<b>Docket Number:</b>	01-AFC-07C
<b>Project Title:</b>	01-AFC-7C Russell City Energy Company
<b>TN #:</b>	211691
<b>Document Title:</b>	Response to Staff's Informational Request for Demineralized Water System
<b>Description:</b>	Project owner responses to staff structural information request for the proposed demineralized water system for Russell City
<b>Filer:</b>	Eric Veerkamp
<b>Organization:</b>	Russell City Energy Company, LLC
<b>Submitter Role:</b>	Applicant
<b>Submission Date:</b>	6/1/2016 11:23:50 AM
<b>Docketed Date:</b>	6/1/2016

**Re: Project Owner's Response to Structural Staff Data Requests  
Russell City Energy Center Petition for Modification Amendment No. 6**

DESIGNER	DATE	TITLE
SCS	05/03/18	PLANVIEW LAYOUT DRAWING
CHECKER	DATE	
SCS	05/03/18	
ENGINEER	DATE	
SCS	05/03/18	
MANAGER	DATE	
TG	05/03/18	
FILE:		
SCALE:	1:50

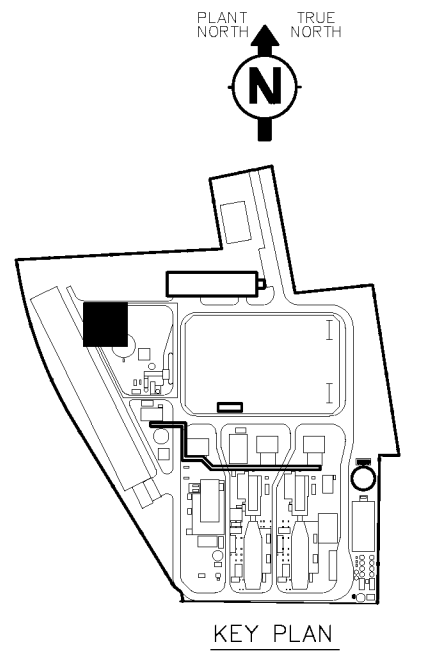
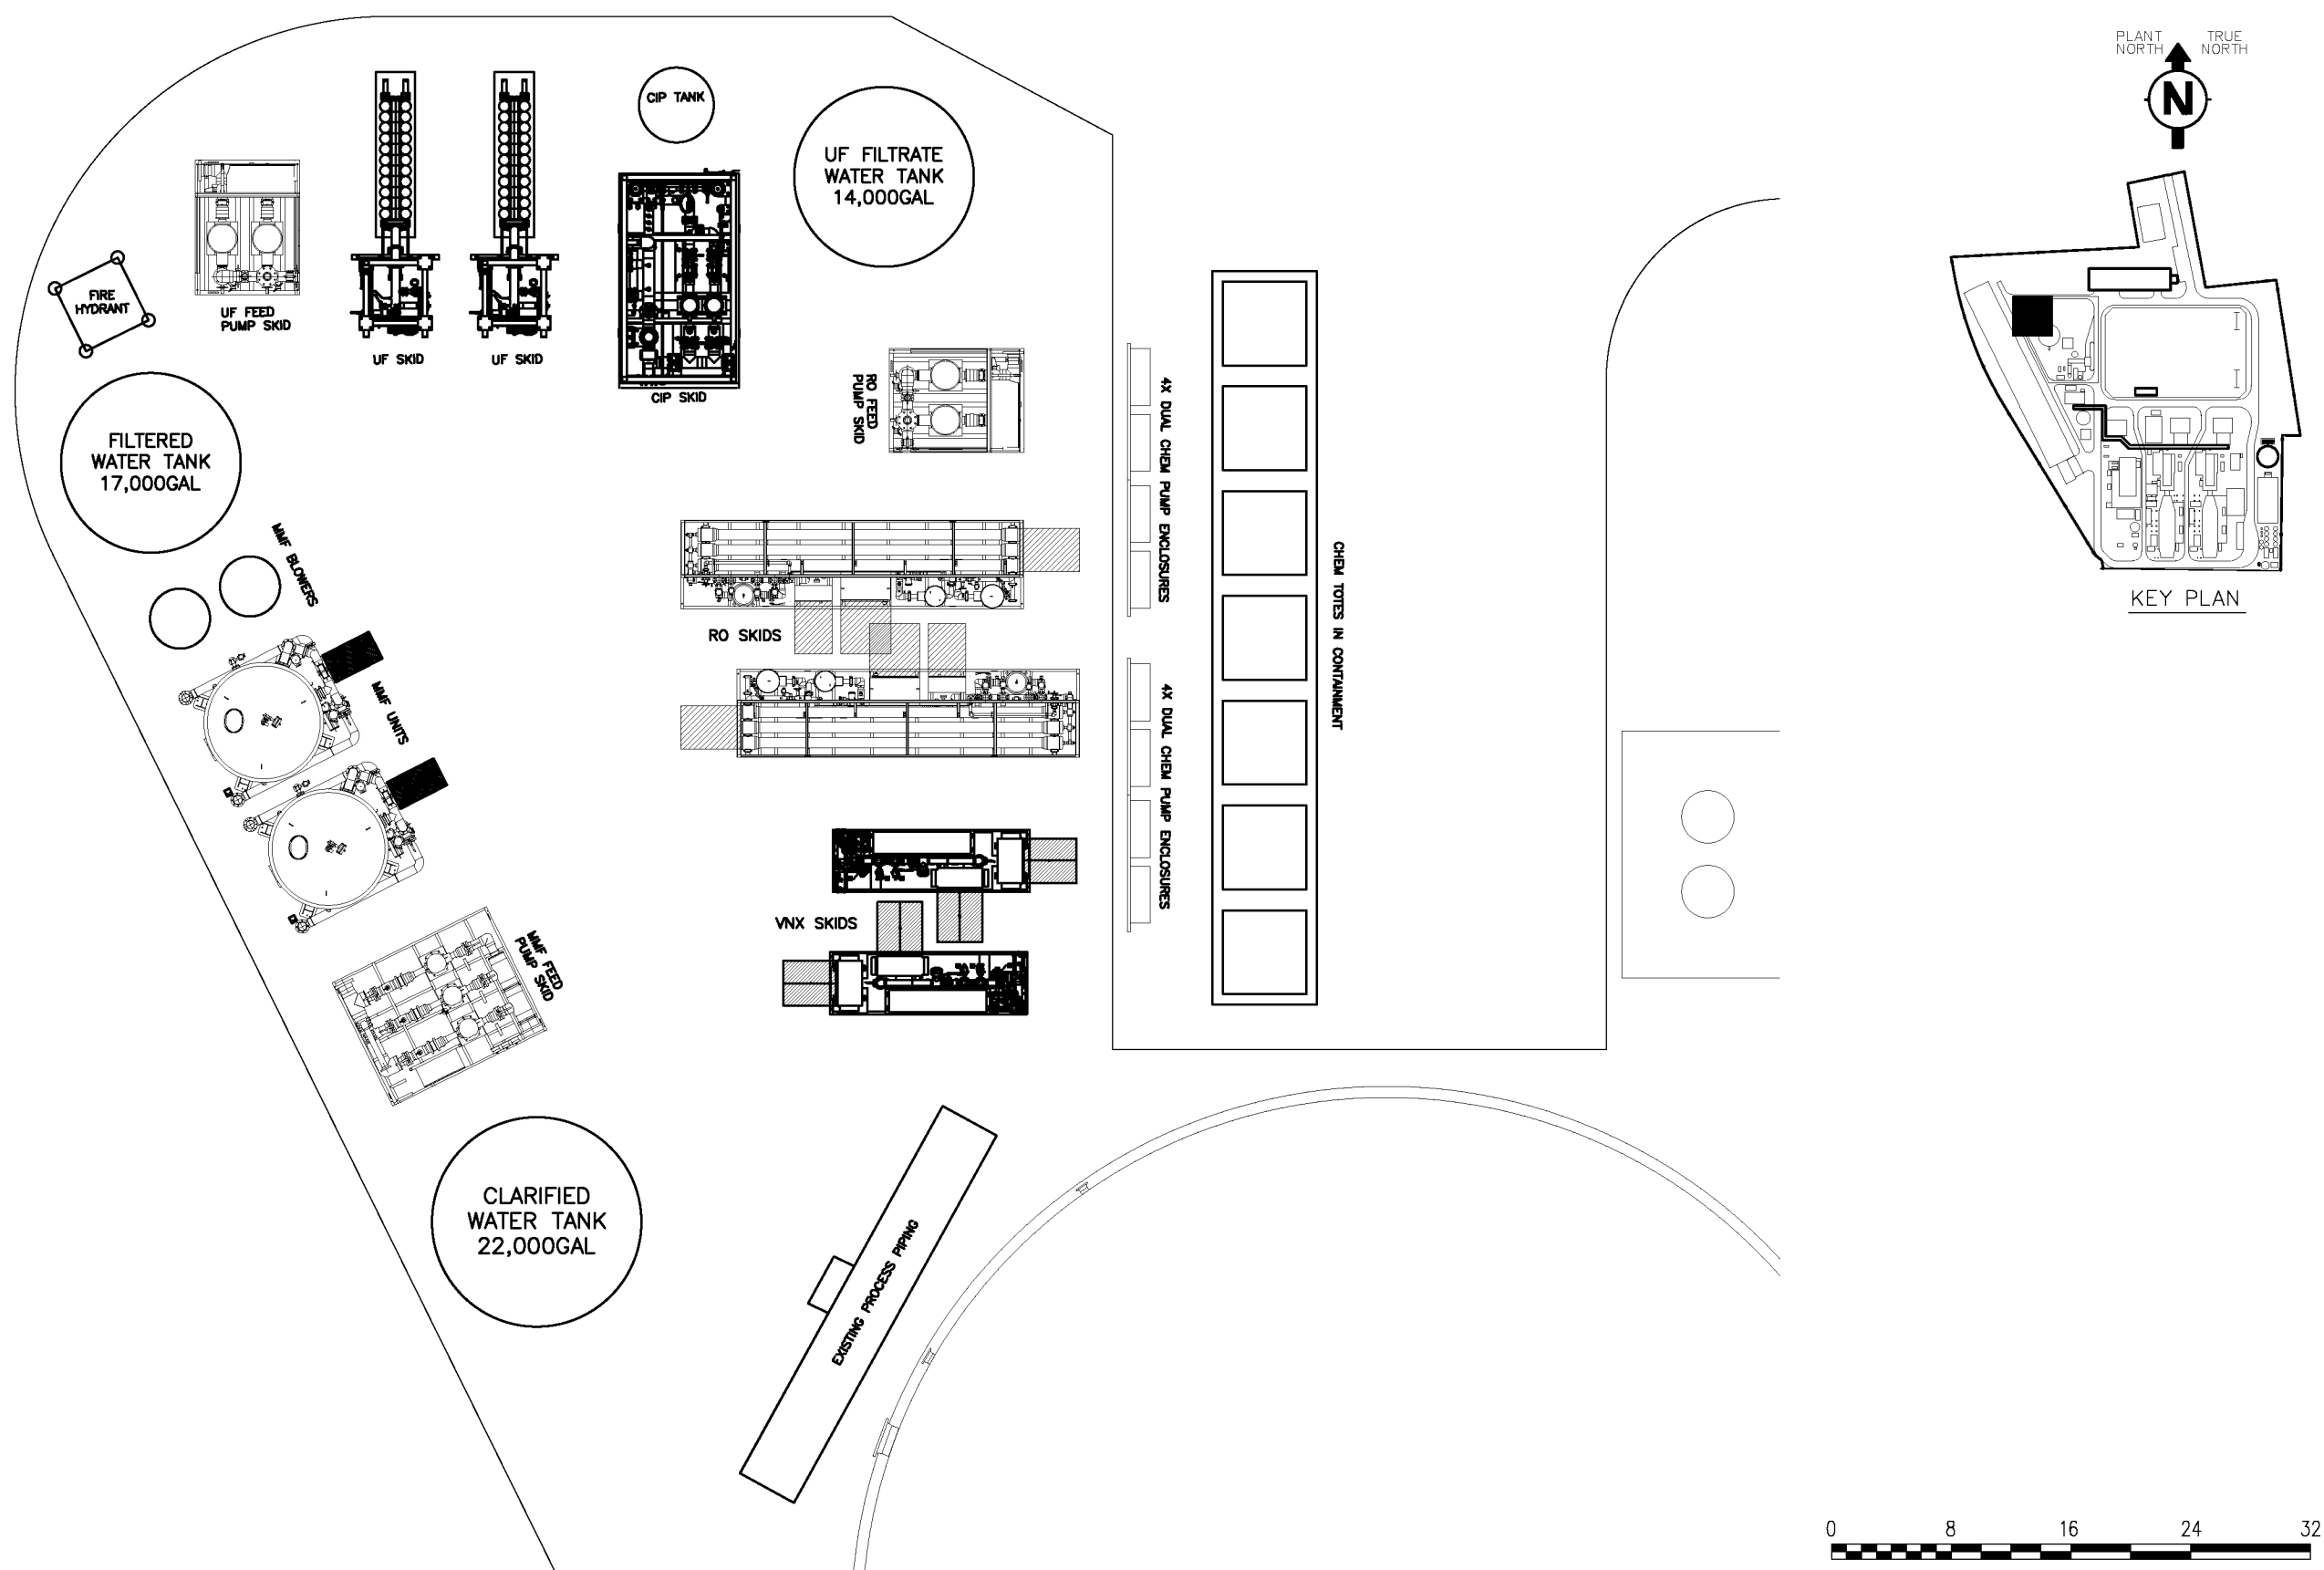
3. The schematic design in Figure 2 is illegible and does not indicate the project location within the larger existing plant site. Please provide a figure on an aerial map base or on the appropriate USGS topographic quadrangle(s) map base which clearly identifies the area in which the project would be located, including water and electrical pipeline locations and connections, locations of skid foundation(s) and other relevant physical elements that may help to describe more fully the project components. This will enable staff to compare the proposed work area to the original project facility locations and where previous work has occurred on site.

**ANSWER: Attached is a preliminary drawing of the proposed layout of the demineralized water system. Also attached is the Russell City Energy Center Site Plan showing the location of the project. More detailed drawings are not yet available as the detailed design process is not yet complete. Drawings will be provided to the CEC as made available. The proposed location of the system is all previously disturbed land, that is otherwise already part of the RCEC facility.**
